MEMORANDUM

OUR REF: 16S1454000

RE: **FASS-Response to Traffic Comments by Department of Planning & Environment (DOPE)**

Figure 1: Pedestrian Desire Lines

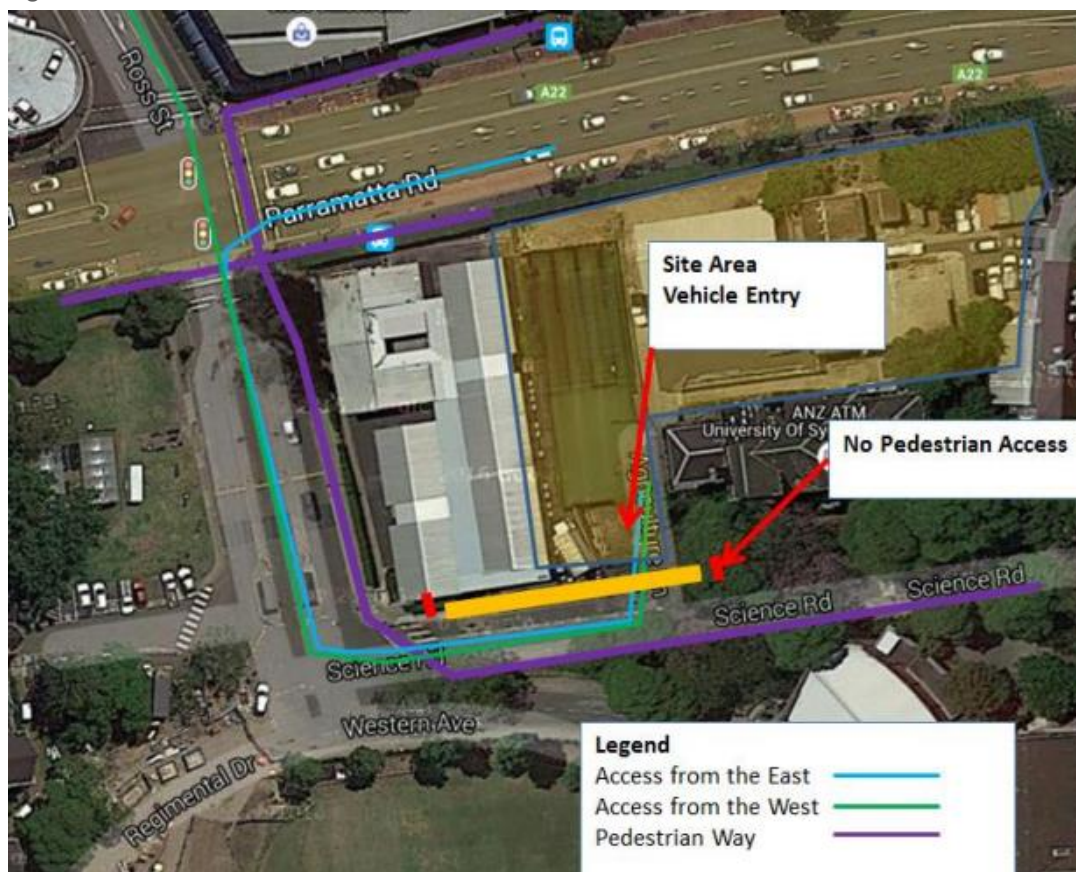
The CTMP also identified the existing pedestrian desire lines surrounding the site (Figure 1).

It is our view that the CTMP has appropriately addressed the safety of pedestrians by introducing a 'No Pedestrian Access' zone in front of the site. However, it is considered that this can be further enhanced by appointing accredited traffic controllers at the Science Road marked pedestrian crossings, in particular during the university term, to provide additional protection to students travelling between Ross Street and Western Avenue. Further, it is our view that water-filled barriers may be appointed at the boundaries of trucks' travel path to provide physical deterrence to students/pedestrians from interfering with truck movements/activities.
